## COUNCIL PANEL SUPPLEMENTARY ASSESSMENT REPORT

<b>Panel Reference</b>	2017SNH084
<b>DA Number</b>	DA0610/17
<b>LGA</b>	Ku-ring-gai
<b>Proposed Development</b>	Demolition of existing structures and construction of a mixed use development comprised of shop top housing containing 56 apartments, use of ground floor commercial space as an Aldi supermarket and small retail suite, basement parking, signage and associated works
<b>Street Address</b>	810-818 Pacific Highway, Gordon
<b>Applicant/Owner</b>	RPS Group / Pacific Highway Gordon P/L & Ku-ring-gai Council
<b>Date of DA Lodgement</b>	11 December 2017
<b>Number of Submissions</b>	7 submissions in response to 1 <sup>st</sup> notification, 1 submission in response to notification of amended plans
<b>Recommendation</b>	Refusal
<b>Regional Development Criteria (Schedule 7 of the SEPP (State and Regional Development) 2011)</b>	CIV in excess of \$20 million Works on land to which Council has an interest in excess of \$5 million

<b>Report prepared by</b>	Kerry Gordon, Michael Zanardo and Kerry Hunter – consultants on behalf of Ku-ring-gai Council
<b>Report date</b>	31 October 2018

**Figure 1**

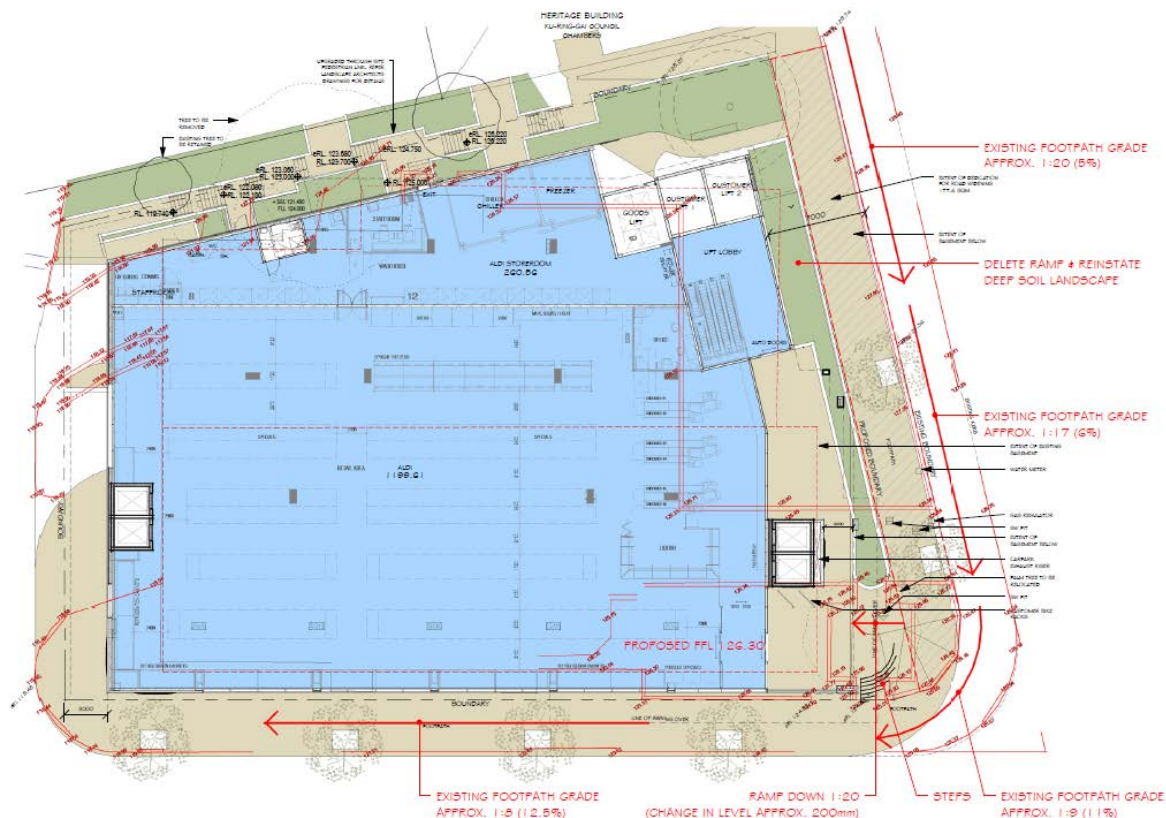
Amended plan raising the ground floor level by 600mm, deleting the ramp to the supermarket from the street and altering the access courtyard at the corner of Pacific Highway and Dumaresq Street.

**Figure 2**

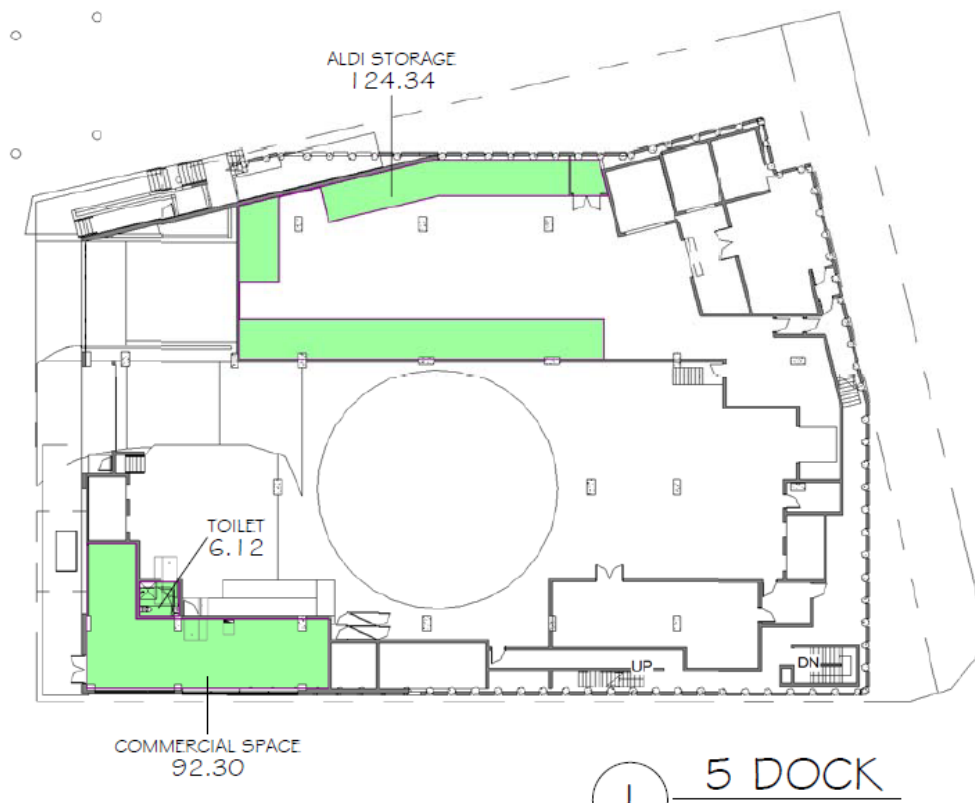
In addition, the volume and height of the building is exacerbated by the dock level which has a floor-to-floor height of 6.1 metres but does not contribute to gross floor area (due to the LEP definition) even though its volume is largely above ground level (towards the rear of the building).

FSR calculation diagram for Dock level [DA20E] showing most of the loading level is not included in the calculation of GFA but adds to the height and bulk of the building.

The minimum height required for such a dock is 4.5 metres, therefore the overall height exceedance of the building is significantly impacted by the height of the dock level by approximately 1.6 metres.

**Figure 4**

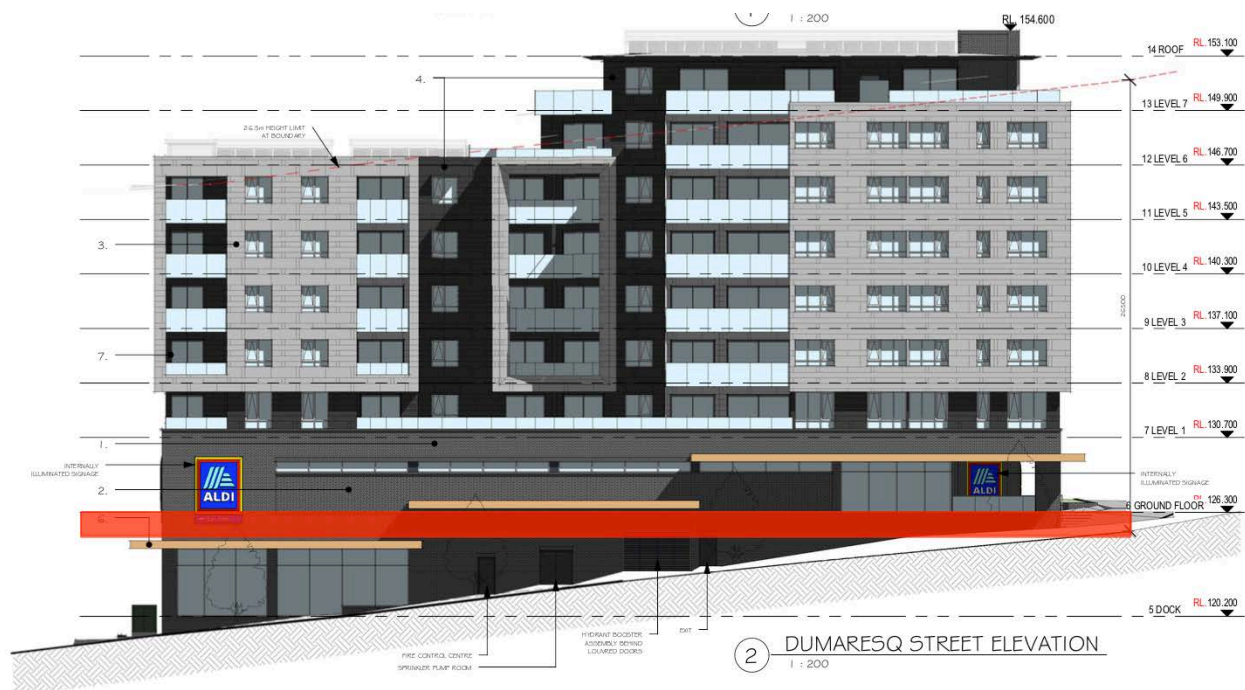
Dumaresq Street elevation [DA14E] showing the additional 1.6m height in red that the dock level contributes to the building over and above what it needs to operate.

### Figure 5

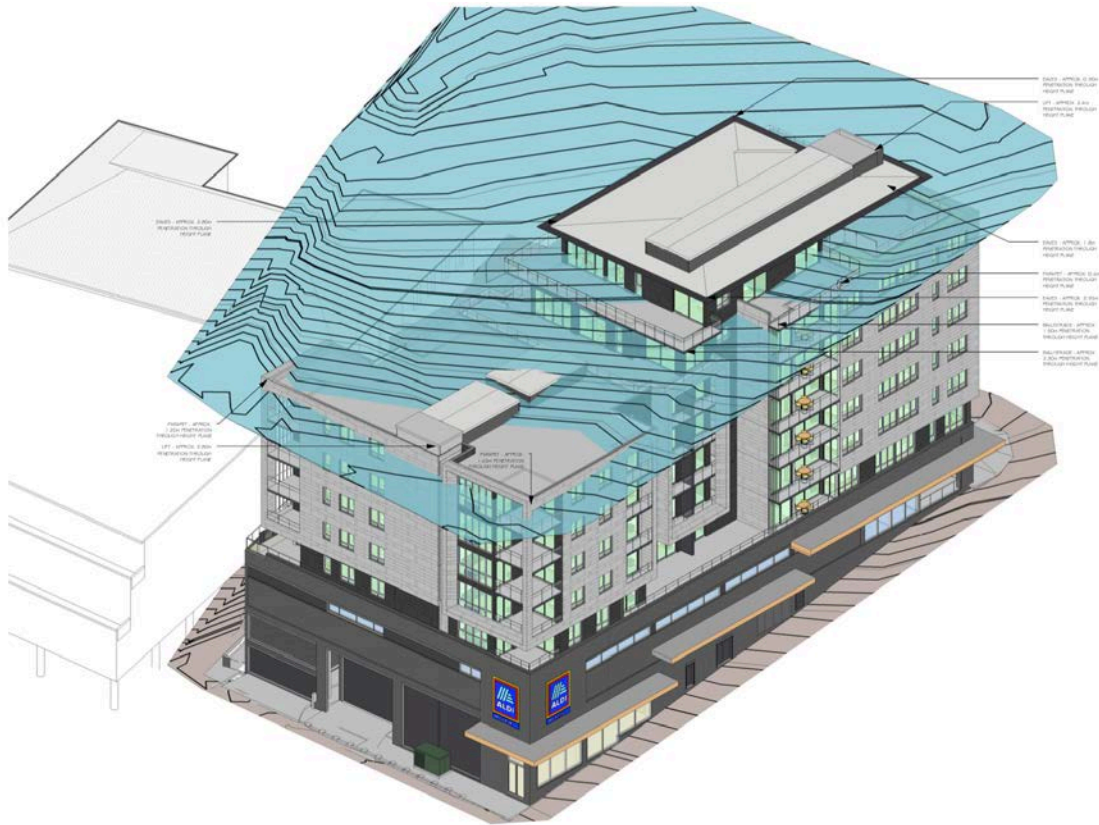
Secondly, the extent of variation to the maximum building height cannot be considered 'minimal'. The extent of variation at 5.11m as described by the Clause 4.6 variation request, or at 4.6 metres as assessed by Council, results in an exceedance of the maximum building height of either 19% or 17%, respectively. Both of these figures are almost double the 10% threshold commonly regarded as 'minor', the type associated with small built form encroachments such as lift overruns and plants in the centre of the building and roof eaves at the perimeter. In this instance, the exceedance means that much of the habitable volume of both penthouse units at Level 7, the entire topmost roof form and all lift overruns and plant rooms above this are above the maximum height plane.

Given the extent of the overrun at almost two full residential storeys in height, it is considered that the topmost floor should be removed. This would leave only more minor encroachments of the height plane such as those that occur at level 5. Alternatively, a planning proposal could be submitted to vary the LEP maximum building height for the site.

### Figure 6

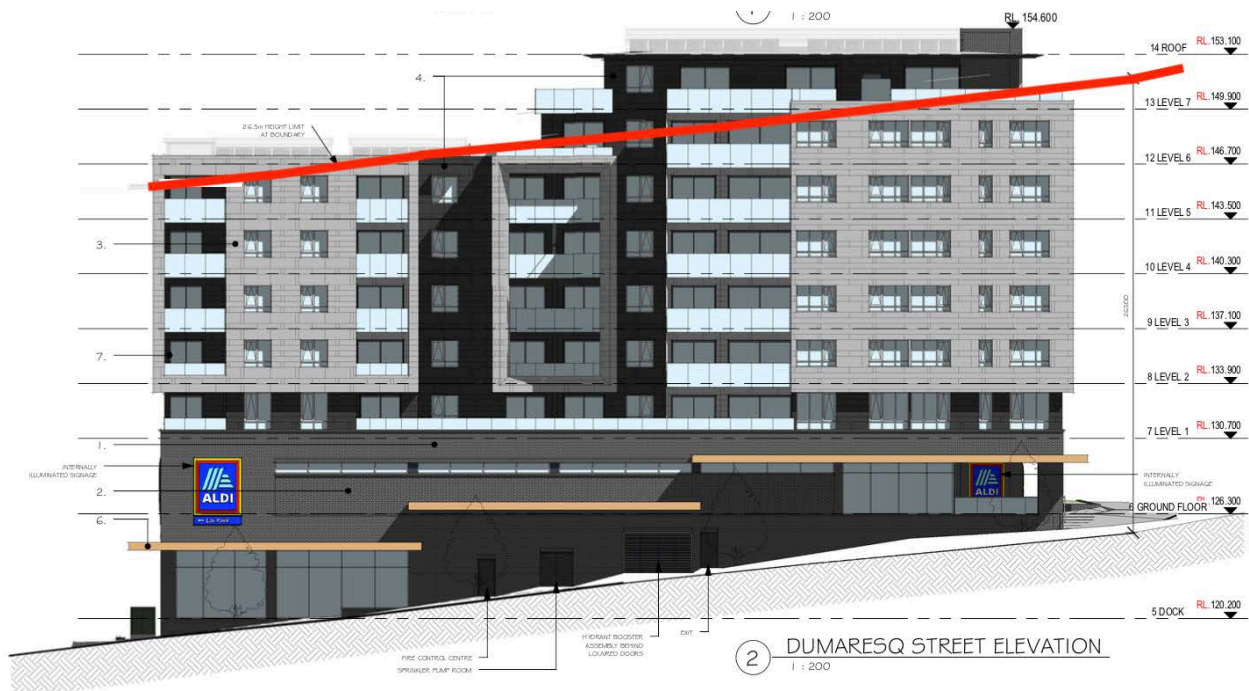
Height plane study [DA22E] showing most of the volume of the top floor breaking through the height plane. Note that downwards view reduces apparent exceedance.

Dumaresq Street elevation [DA14E] with height plane highlighted showing most of the volume of level 7 above the height plane. Note that other elevational views appear to show the height plane at the boundary rather than at the face of the building and are therefore not accurate indications of height breach.

in this instance where there are large encroachments of the height plane of greater than an entire residential floor-to-floor height, the appropriate, or 'reasonable', way to respond to the steep slope of the site is to remove the topmost floor of the building (Level 7).

**Figure 16**

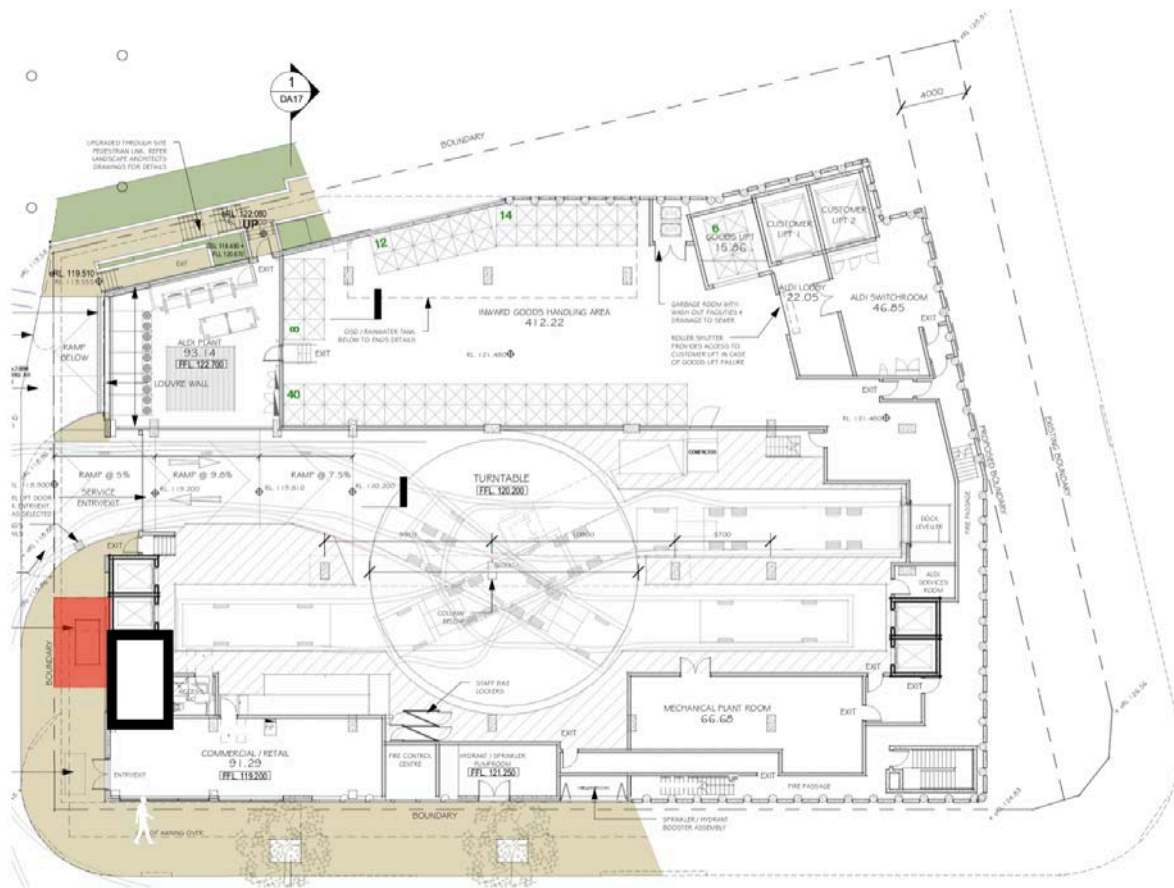
Whilst it is possible to locate the substation in the centre of the footpath that is to be dedicated to Council at no cost (Part 14D.9 7(vi)), it is not desirable. This location will have a negative impact on the public domain. The substation should be incorporated within the final boundary of the site. A suitable location appears to be available on the southern side of the western lift. The high floor-to-ceiling height of the dock level appears to provide adequate clearance for service of the substation and provision of adequate structure to protect from any additional blast.

Loading Dock plan [DA04F] showing proposed location of substation in red and suggested location outlined in black.
